**CHARLOTTE HISTORIC DISTRICT COMMISSION**  
**CERTIFICATE OF APPROPRIATENESS**

**CERTIFICATE NUMBER:** HDCRMA-2019-00364

**ADDRESS OF PROPERTY:** 1822 Wickford Place, Lot 2

**A NEW RESIDENCE AT: WILMORE #2**  
WILMORE02  
DATE: NOVEMBER 21, 2016  
DRAWN BY: MSB  
CHECKED BY: MSB  
REVISIONS:  
NO. DATE BY  
COMPUTER REFERENCE NUMBER  
WILMORE0201 -125  
SHEET NO.  
A1.0 OF 4

101 LOWER LEVEL PLAN  
A1.0

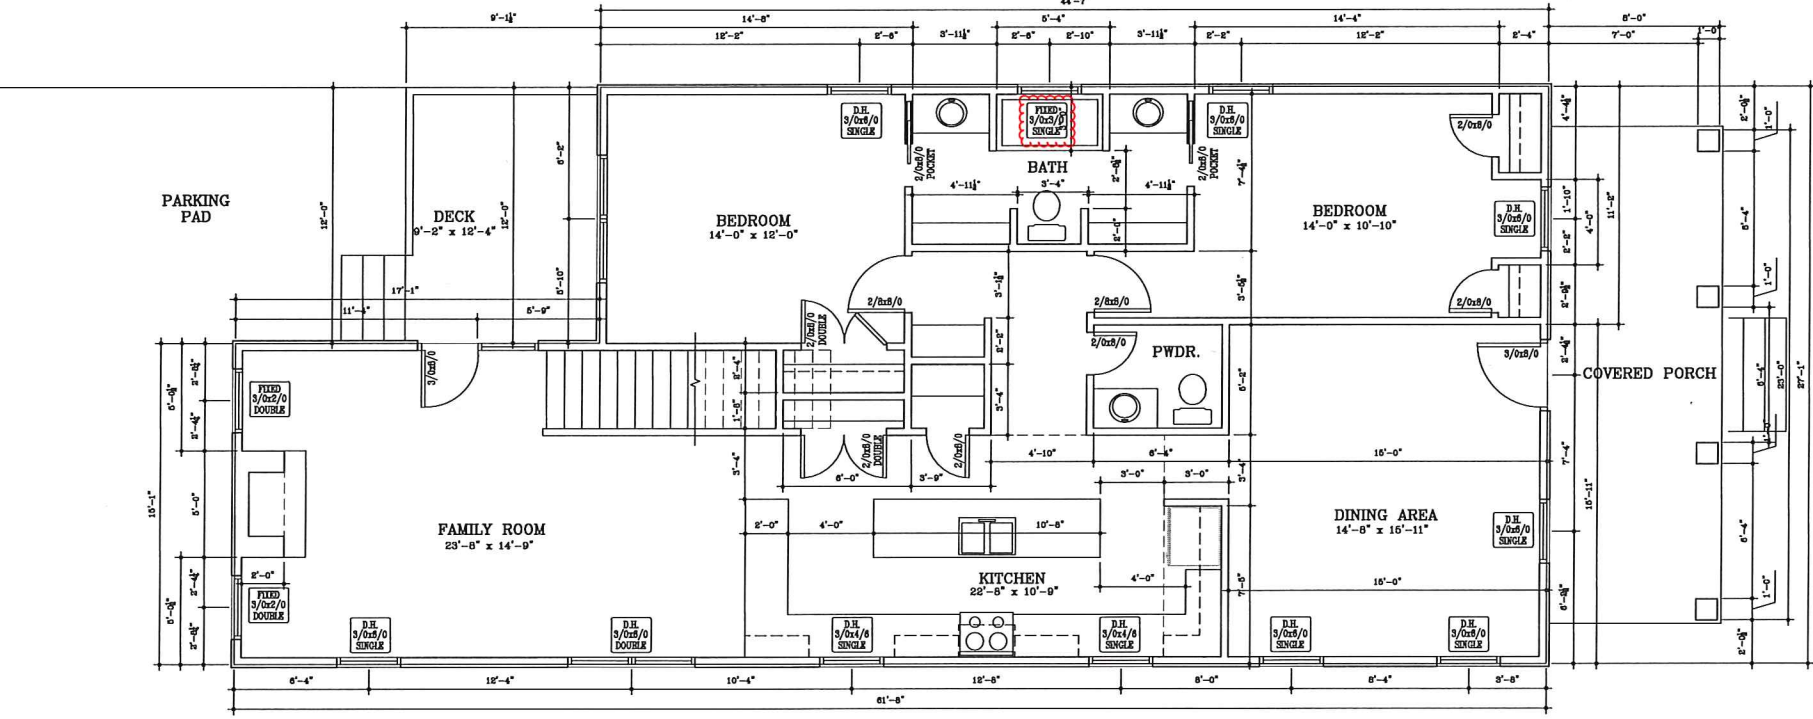
REVISED SQUARE FOOTAGE ON BUILDING PERMIT APPLICATION / HEATED IS 2062 SF FOR FIRST & SECOND FLOOR / UNHEATED IS 185 SF FRONT PORCH / DECK 112 SF

FOUNDATION PLAN

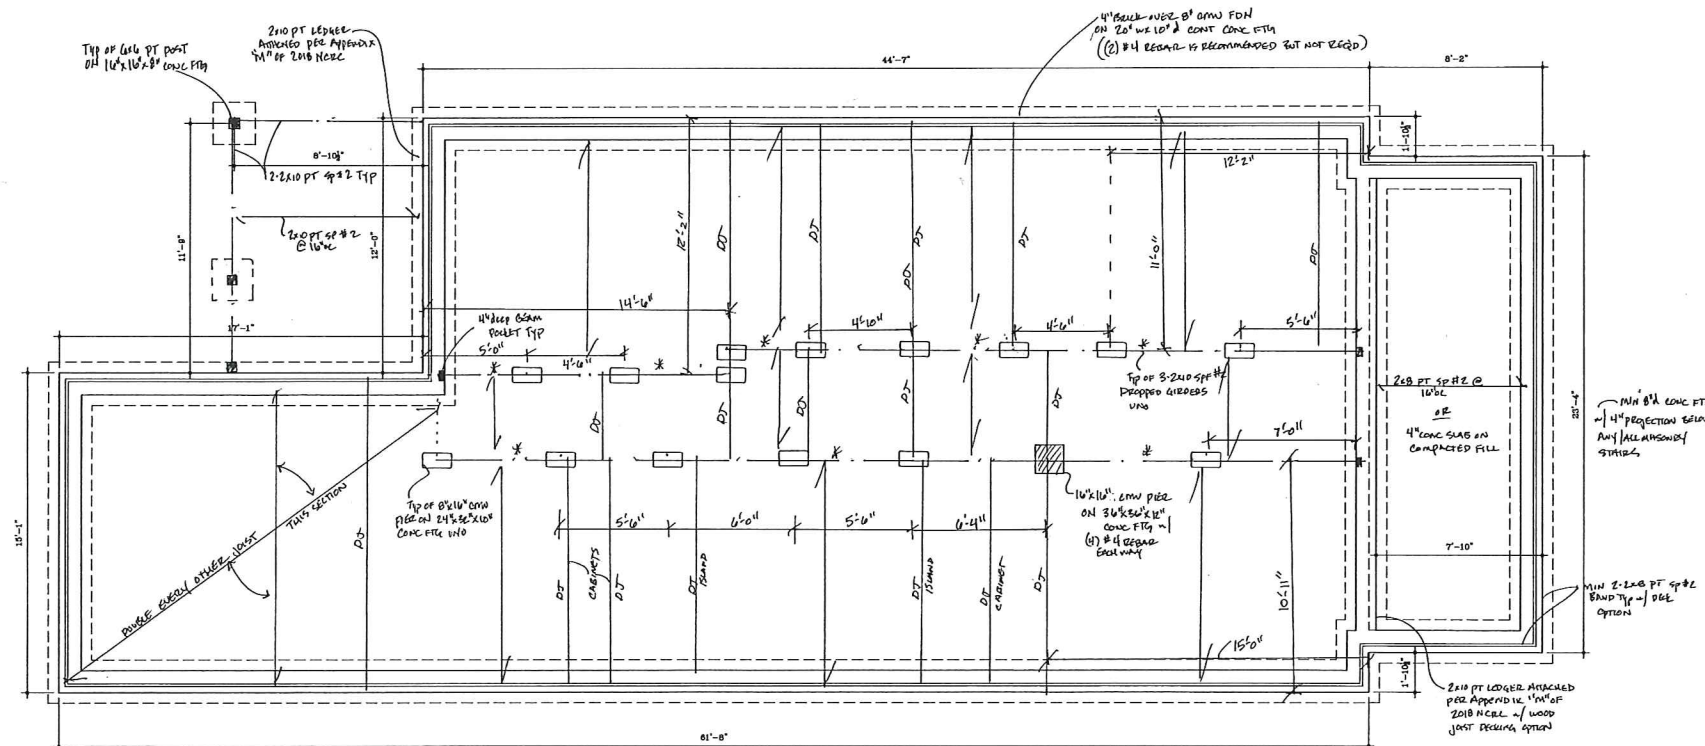
R408.8 PROVIDE CRAWL SPACE ACCESS MINIMUM SIZE 18 INCHES x 24 INCHES

R408.1.2 PROVIDE FOUNDATION VENTS WITHIN 3 FEET OF EACH CORNER

R408.2 PROVIDE MIN 6 MIL POLY VAPOR BARRIER IN THE CRAWL SPACE

ROOF PLAN

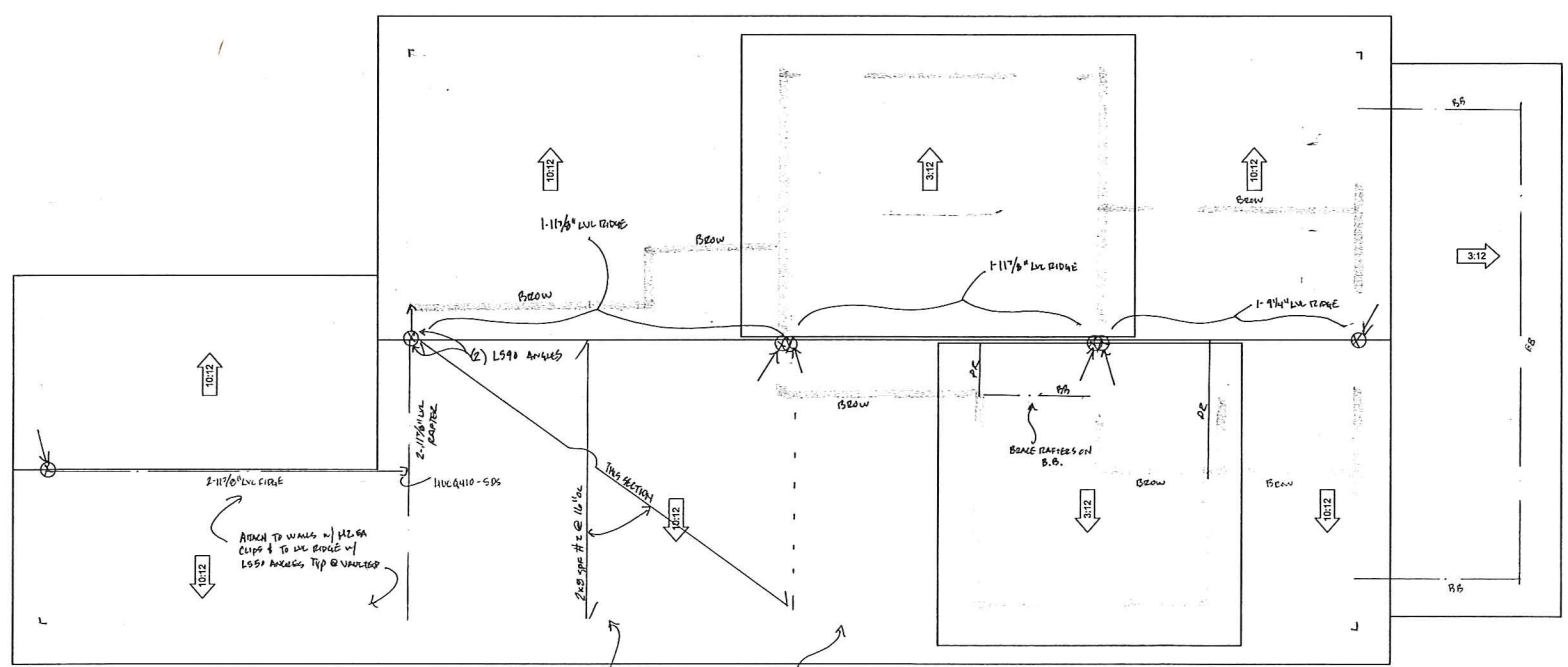
R905.2.2 PROVIDE 2  
LAYERS UNDERLAYMENT  
ON ROOF WITH LESS THAN  
4:12 PITCH WHERE  
ASPHALT SHINGLES ARE  
USED

WINDOW DETAIL – UPDATED

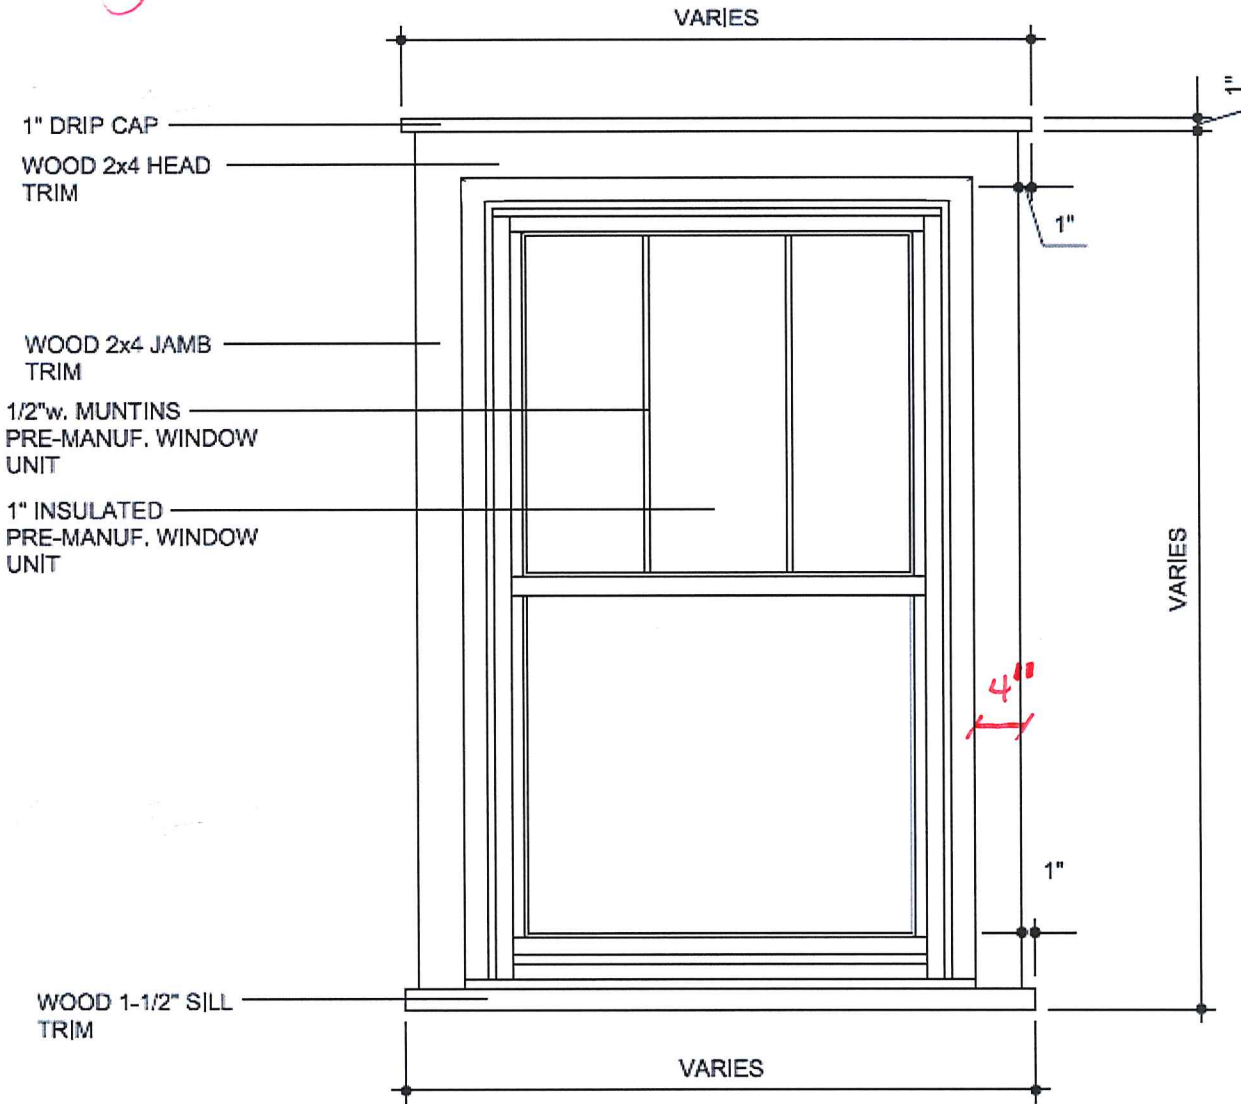
- use casing/trim appropriate to wood Siding
- 4" wide non-tapered trim
- 7/8" putty glaze
- double hung wood window
- 3-over-1 simulated true divided light

**SOFFIT DETAIL – UPDATED OPEN TAIL**

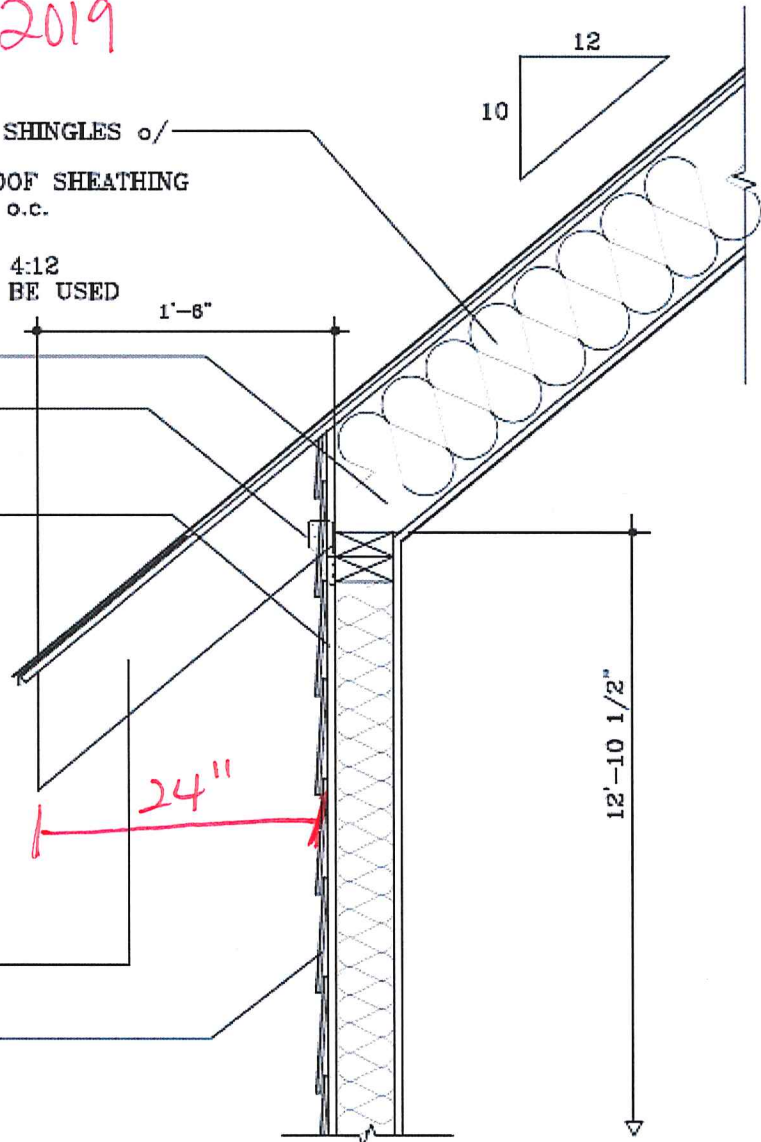
• roof overhang to be  
24" - measured at a  
right angle to siding

• 7 1/4" barge rafters  
with bed mold base
